TECHNICAL MODIFICATIONS FOR THE FLOWER MARKET PROJECT; CF 19-1048 / 19-1048-S1

CF 19-1048, CASE NO. VTT-74568-1A

Revised Exhibit A

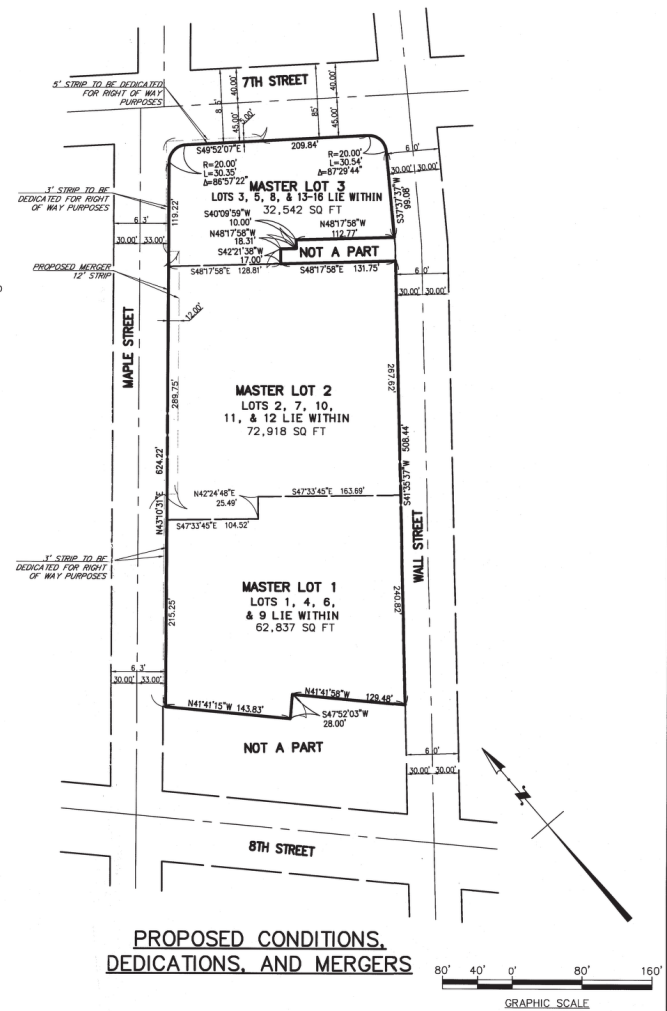
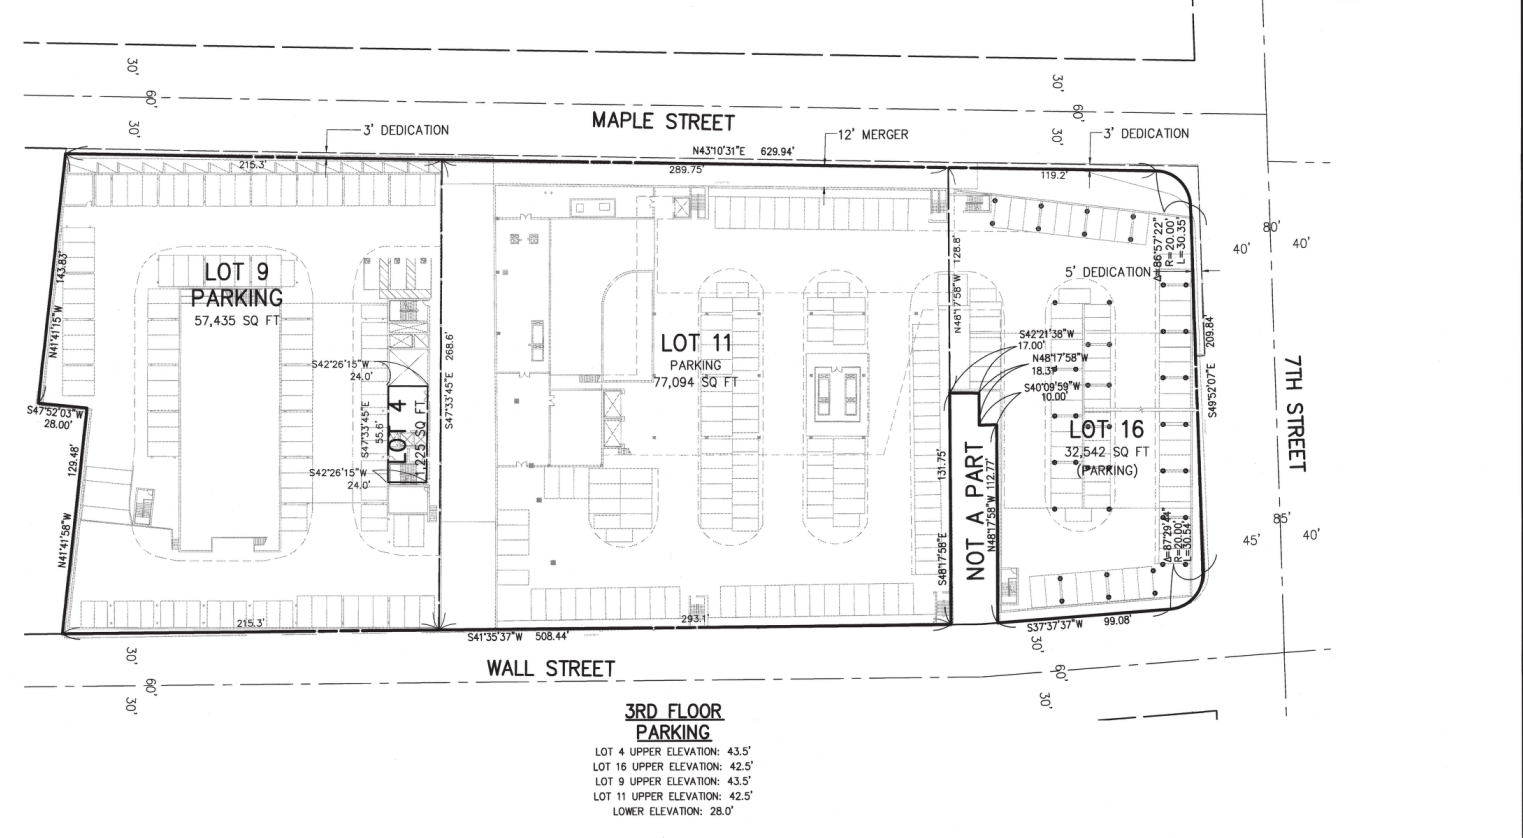
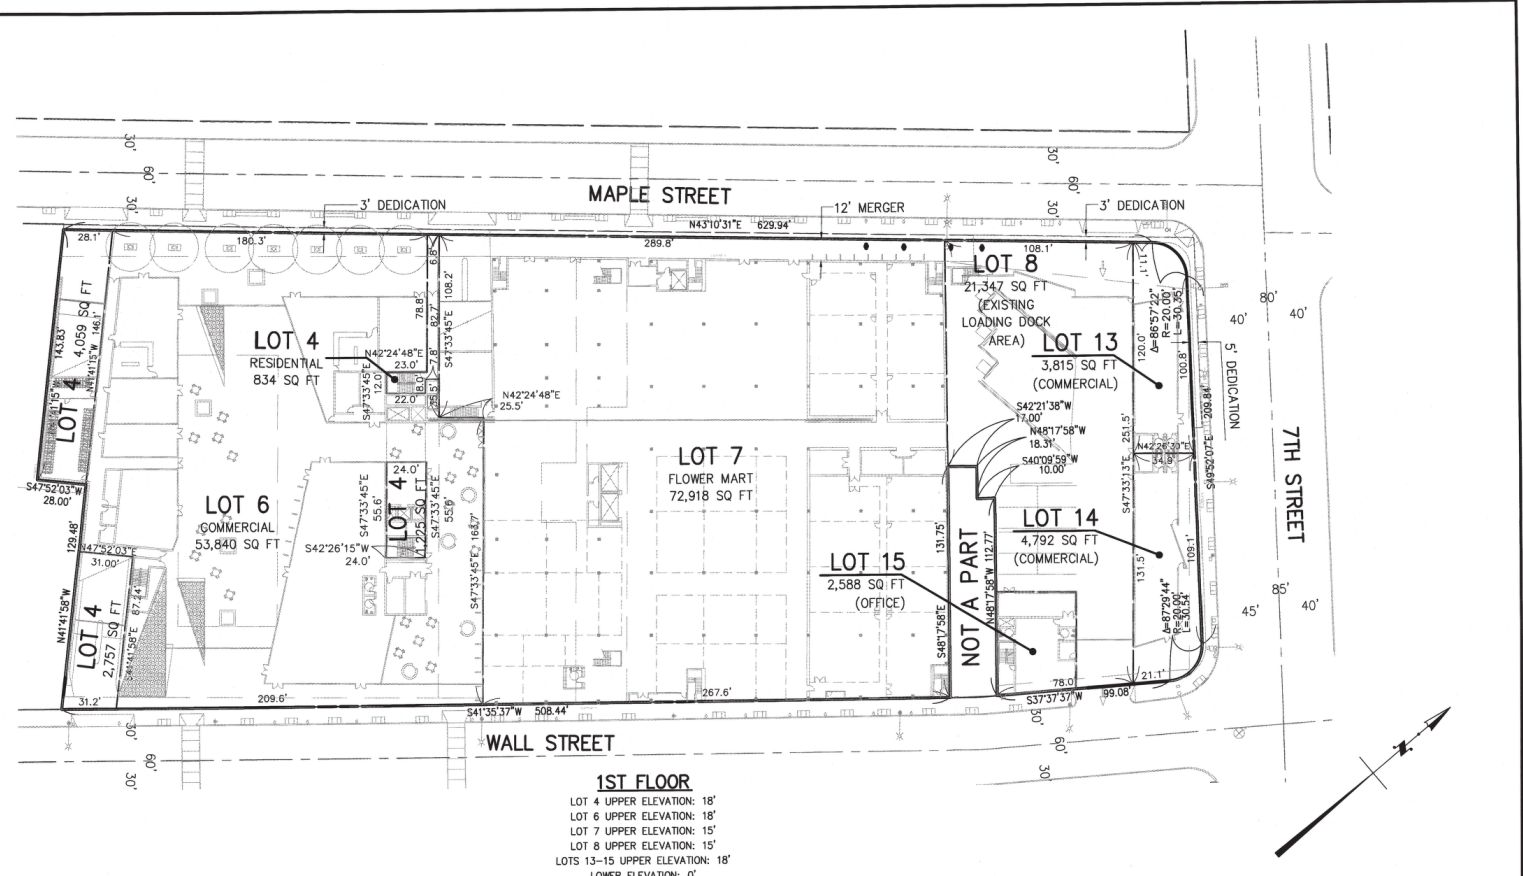
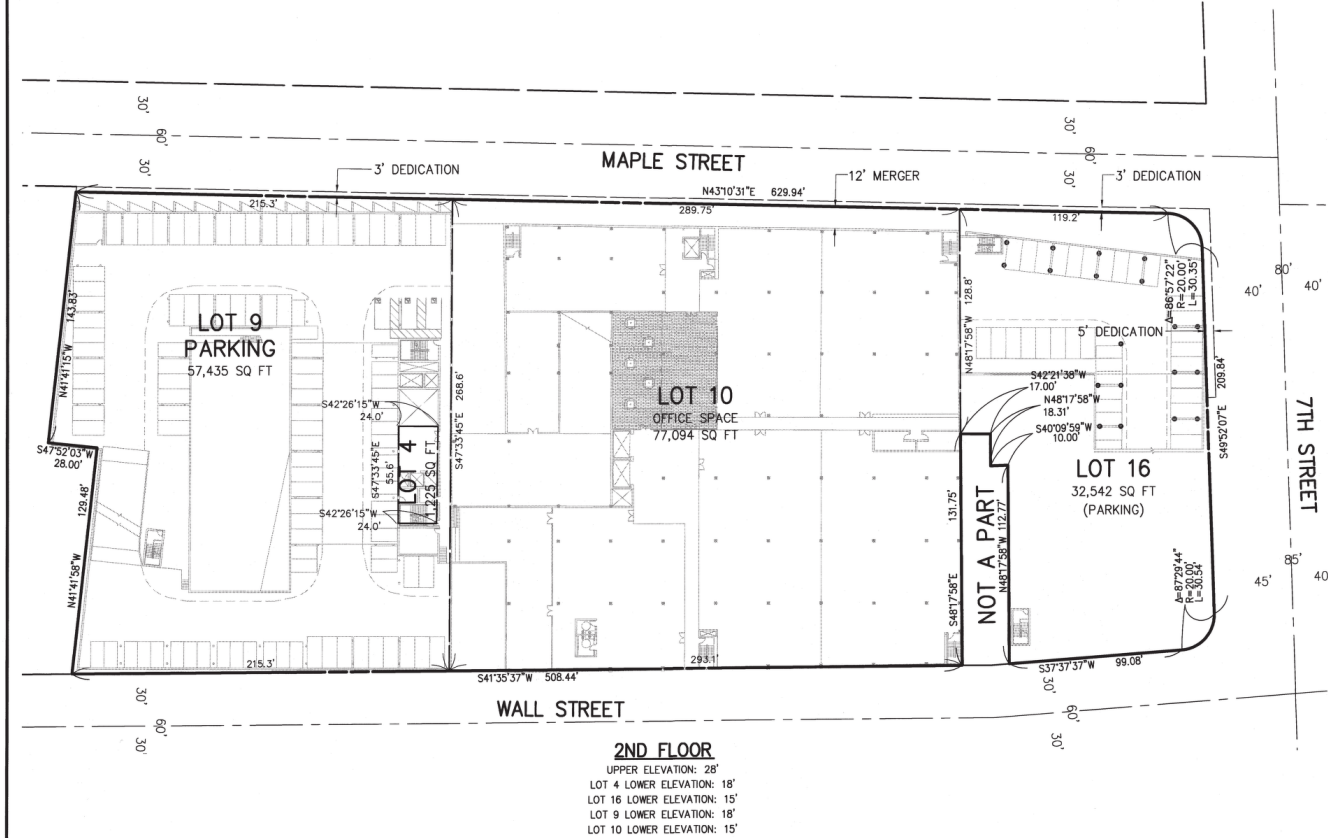
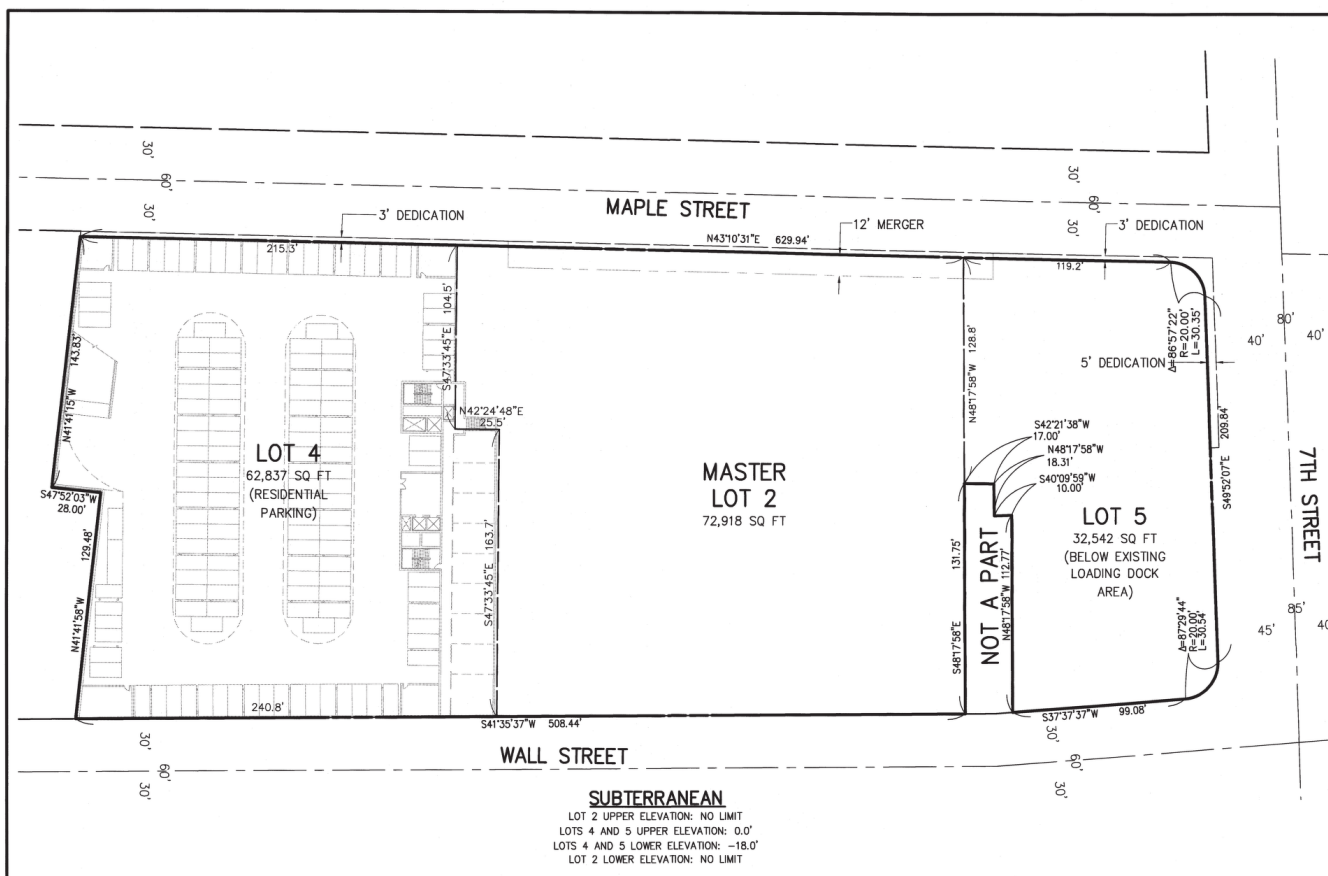
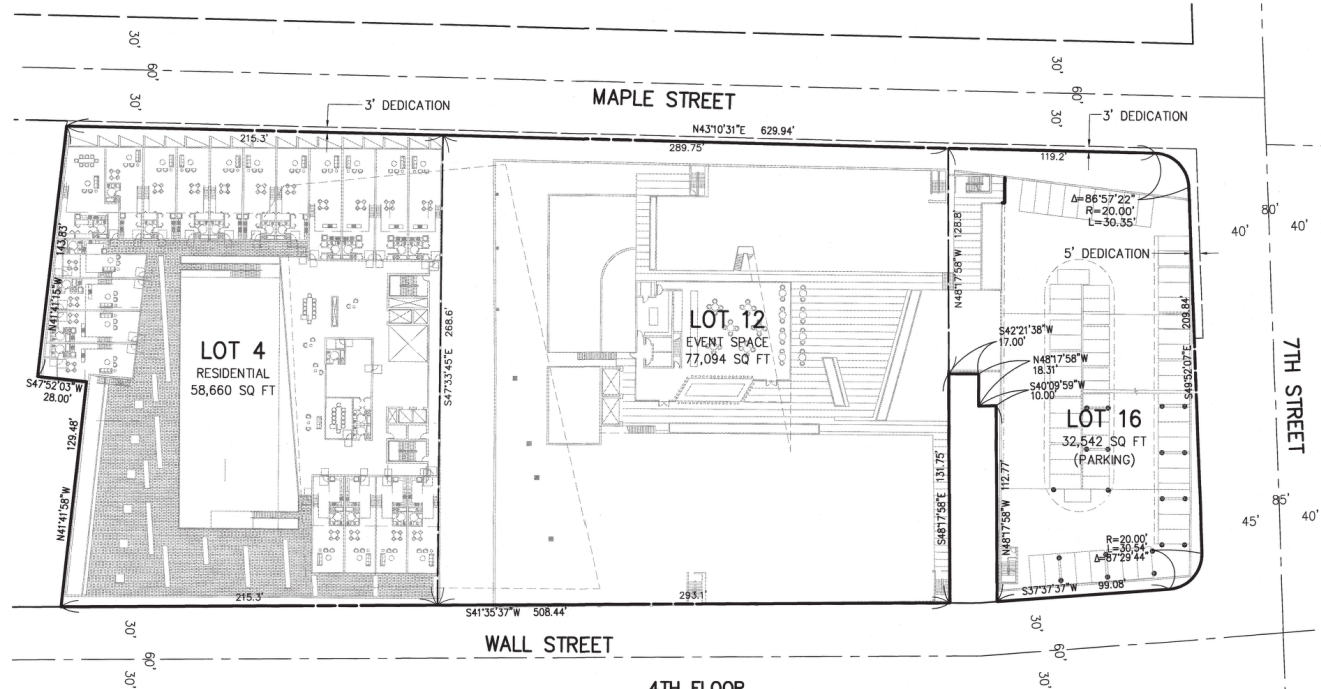
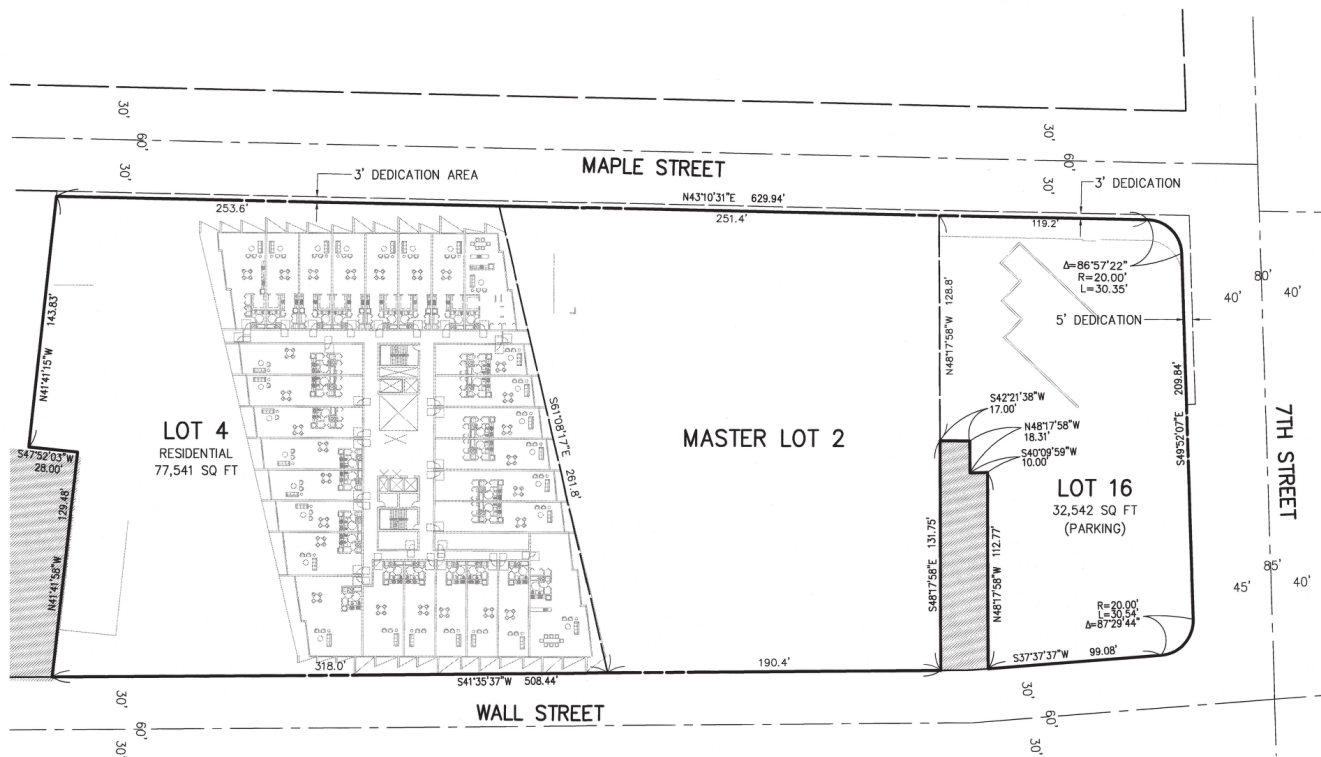
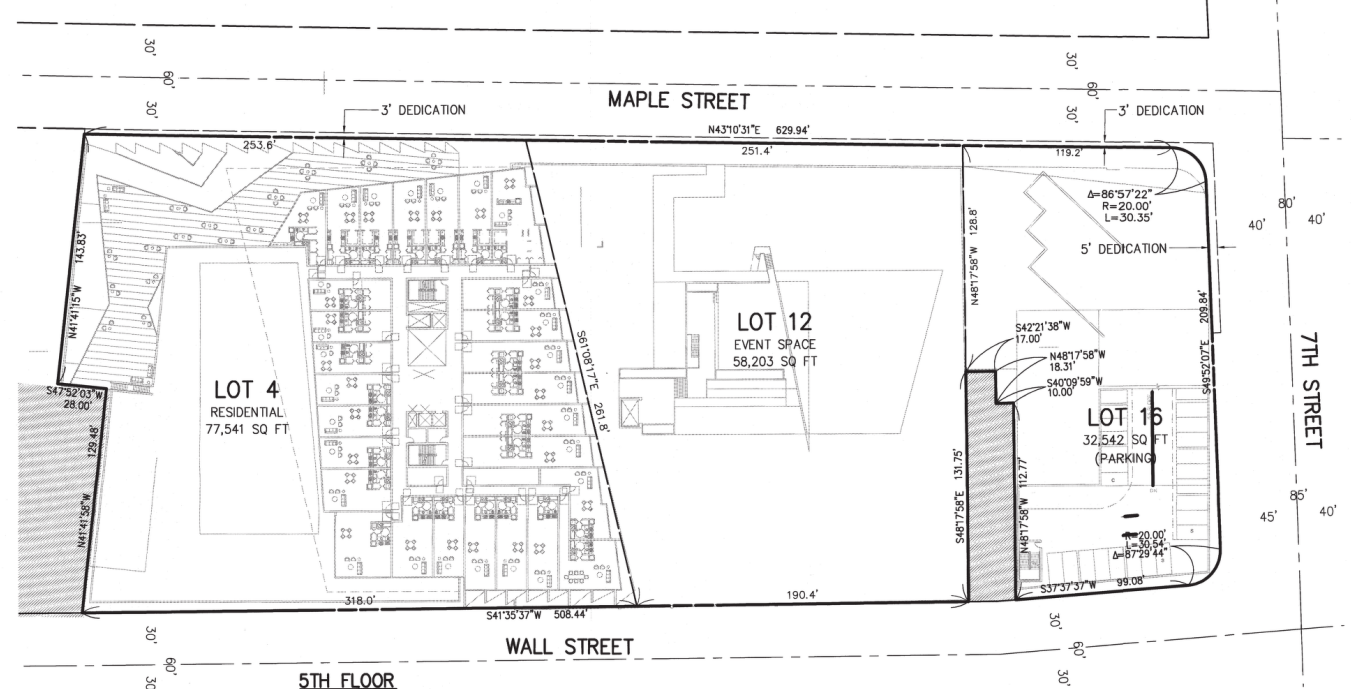
The Letter of Determination (LOD) for VTT-74568, dated June 3, 2019, referenced a Vesting Tentative Tract (VTT) map stamped-approved July 11, 2018. However, a map stamp-dated October 15, 2016 was inadvertently attached to the LOD as the approved Exhibit A, and carried forward as part of the Exhibit C in the Appeal Report to the CPC dated August 8, 2019. The correct map is actually dated February 9, 2018, and was inadvertently referenced with the July date due to a separate stamp on the map from the Department of Building & Safety Grading Division dated July 11, 2018.

Staff recommends that that any reference in the Vesting Tract Map LOD and Conditions of Approval to the July 11, 2018 date be replaced with the February 9, 2018 date; and that the VTT map dated February 9 2018, attached an Enclosure to this letter, replace the existing Exhibit A wherever referenced.
